APPENDIX N. PUBLIC COMMENT LETTERS AND RESPONSES

Appendix N-1: 2024 Plan Public Comment Letters and Responses

RE: Kern County Subbasin May 2024 Draft Groundwater Sustainability Plan - Subsidence

RE: Response to Western State Petroleum Association (WSPA) Comments Dated August 29, 2024, on the May 2024 Draft Groundwater Sustainability Plan (GSP), Kern County Subbasin, Related to Land Subsidence.

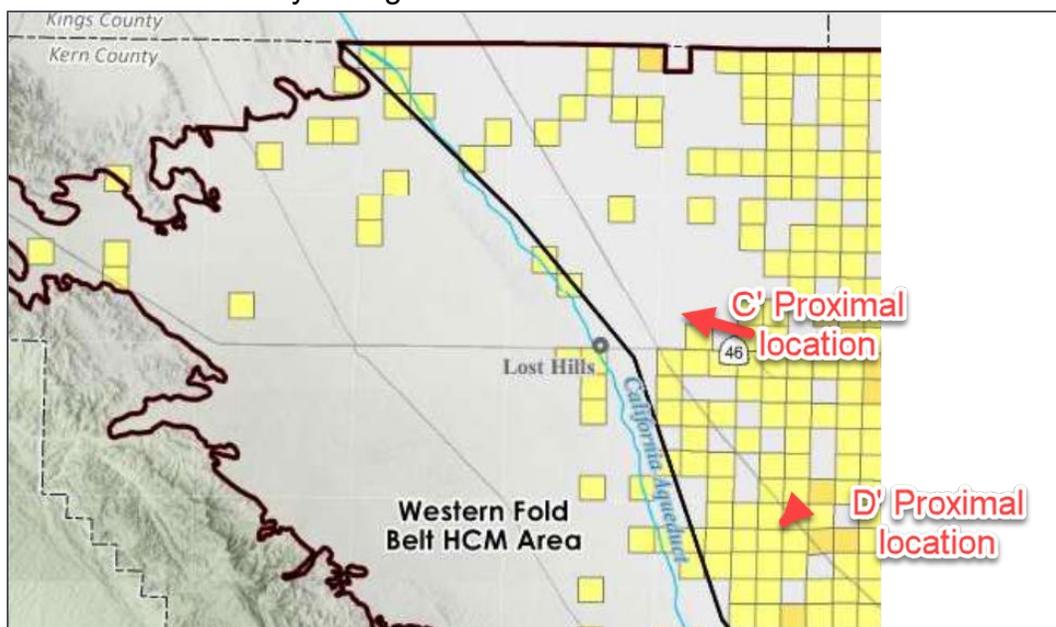
- Groundwater Monitoring on the West Side of the Subbasin: As illustrated in figure 15-6, no groundwater monitoring is proposed on the West Side, including proximate to the LHOFF. This is problematic because without monitoring it will not be possible to differentiate between GSA and non-GSA attributable subsidence. Additionally, figure 8-7, reproduced below, includes a graph of monitoring well 25S20E26M0010⁷ as evidence of stable groundwater elevations in the Western Fold Belt HCM. This single representative hydrograph does not demonstrate current (or future) stable groundwater elevations because it is limited to the timeframe of 1975 to approximately 2004—i.e., the data provided ends more than 10 years before SGMA was enacted. It is inappropriate to draw the conclusion that groundwater elevation is stable without considering what is happening during the relevant SGMA timeframe commencing in 2015.

⁷ While the chart refers to MW 25S20E26M0010, the text references 35S20E26M0010.

Figure 8-78. Time Series for AOI-2 Track D-D' Aqueduct Milepost 210

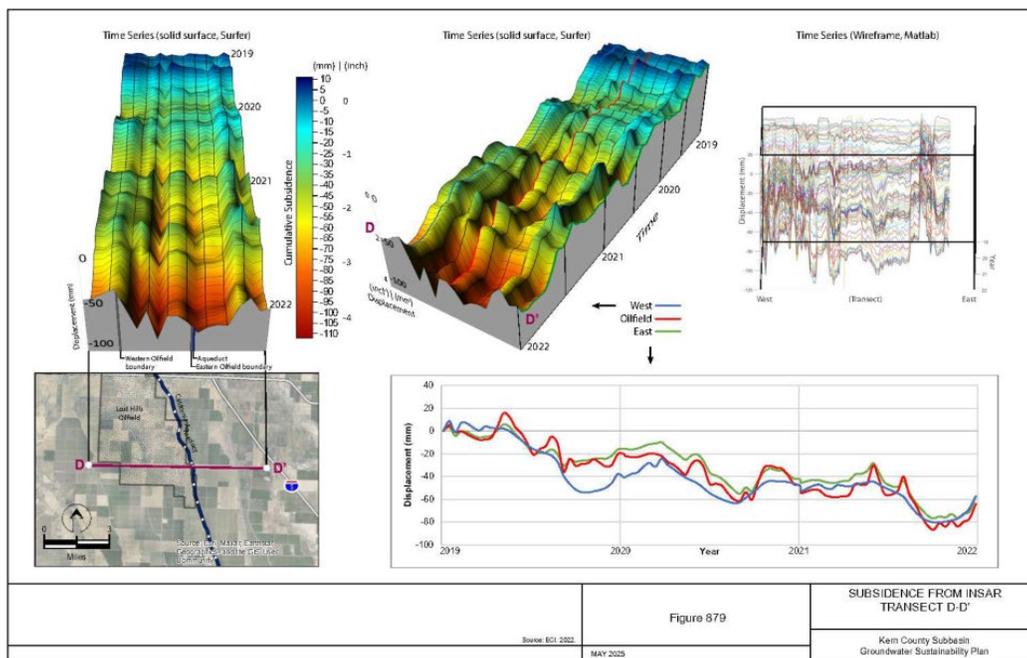
- **Failure to Analyze Subsidence East of the Aqueduct with Actual Groundwater Pumping Volumes Within the GSA's Authority:** The June 2025 GSP for the Lost Hill area does not identify any volumes associated with groundwater pumping wells in the Western Fold HCM Area. However, the June 2025 GSP figure 5-12 shows the presence of groundwater wells east of the Aqueduct in a number of cells as illustrated by the figure below.

Specifically, figure 5-12 highlights sections of grid having between 1 and 5 production groundwater wells. If you compare figure 5-12 to figures 8-77 and 8-78 reproduced below, it is visible that the eastern half of the cross section goes into areas where there is groundwater pumping. For reference, C' data point is on the east side of the I-5 and D' is just west of the I-5. Figure 5-12 shows a number of grid cells that contain groundwater wells west of the I-5 yet the June 2025 GSP provides no data on groundwater pumping in that area. The eastern edge of the subsidence impacts are far east of LHOV and overlap with the grids showing groundwater wells in figure 5-12. This GSA-related data is omitted from the June 2025 GSP. Rather than omitting it, the data should be considered in the June 2025 GSP. Further, the cross sections in figures 8-77 and 8-78 show improvement in subsidence west of the Aqueduct and then a second bowl east of the Aqueduct. The subsidence impacts east of the Aqueduct need to be studied in relation to the groundwater wells represented by the yellow cells in figure 5-12.

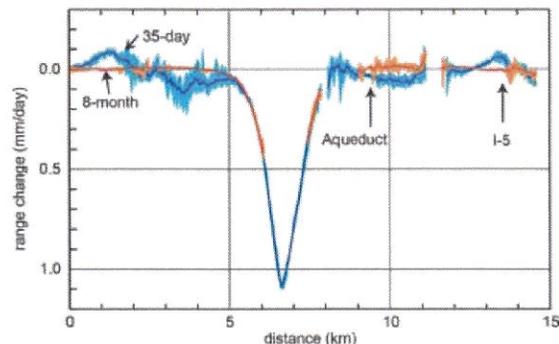
NO EVIDENCE THAT CHEVRON'S LHOF CAUSED AQUEDUCT SUBSIDENCE

There is localized subsidence in the immediate vicinity of Chevron's LHOF operations, but that subsidence does not extend to the Aqueduct. As detailed below there is no evidence that Chevron's LHOF operations have caused Aqueduct subsidence.

- The difference in land subsidence signatures between the area of Chevron LHOF operations and the Aqueduct proves Chevron's operations are not responsible for Aqueduct subsidence. The signature of land subsidence in the Chevron LHOF operating area correlates with the temporal pattern of net fluid balance (i.e., oil and water extractions minus re-injection of produced and make-up water) associated with its operations. The Aqueduct land subsidence signature is different from Chevron's LHOF subsidence signature and does not correlate with the temporal net fluid balance pattern in the Chevron LHOF operating area.

- Chevron's LHOF land subsidence signature patterns correlate with Chevron's LHOF net injection profile while the Aqueduct land subsidence signature does not.

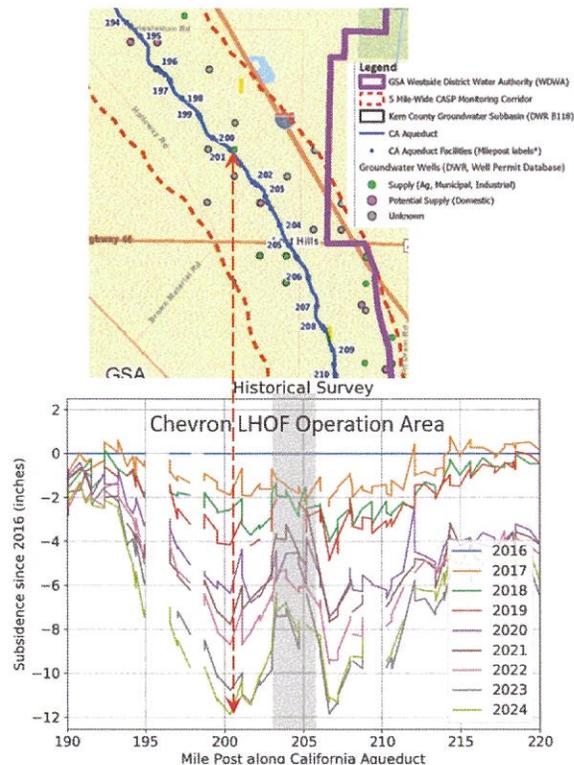
- Section 8.4.4 of the June 2025 GSP maintains that the make-up water supply wells in the Kern County Subbasin, including three of Chevron’s wells near the LHOFF, “are not considered significant for SGMA planning purposes.” While the GSP considers them not to be significant, Chevron maintains that its three wells have *no—rather than an insignificant—*impact on the subsidence observed at the Aqueduct.¹

- The GSP’s claim that there is limited to no groundwater being pumped for GSA-related purposes in the northwestern part of the Kern County Subbasin is inconsistent with available data. As noted in Section 5.6.1 of the June 2025 GSP, the GSAs have yet to complete the Subbasin-wide well inventory making any claims related to groundwater pumping in the northwestern part of the Subbasin premature. Moreover, groundwater monitoring well 21MW-5, screened between 565.8 - 595.0 ft below ground surface (below the Corcoran clay) just to the east of the Aqueduct MP 202 to monitor the cleanup activities associated with a former percolation pond, shows groundwater depths declined by roughly 2.8 ft/yr between 2015 and 2023. This data shows that groundwater extraction, unassociated with the LHOFF is occurring. Similarly, the June 2025 GSP Appendix N figure at page 56, which identifies groundwater supply wells in the vicinity of the Aqueduct, includes a supply well at approximately MP 200, immediately adjacent to the Aqueduct as illustrated below. The June 2025 GSP does not provide any information on the draw down from this well or its general usage. Likewise, the figures show that surveyed Aqueduct subsidence is less between MP 203-206, which correlates with less agricultural activities in the vicinity of the Aqueduct east of the primary area of Chevron’s LHOFF operations.

Contrary to the GSAs’ claims, these examples show that there is a GSA-related subsidence factor (i.e., groundwater pumping) in the vicinity of the Aqueduct that needs to be evaluated
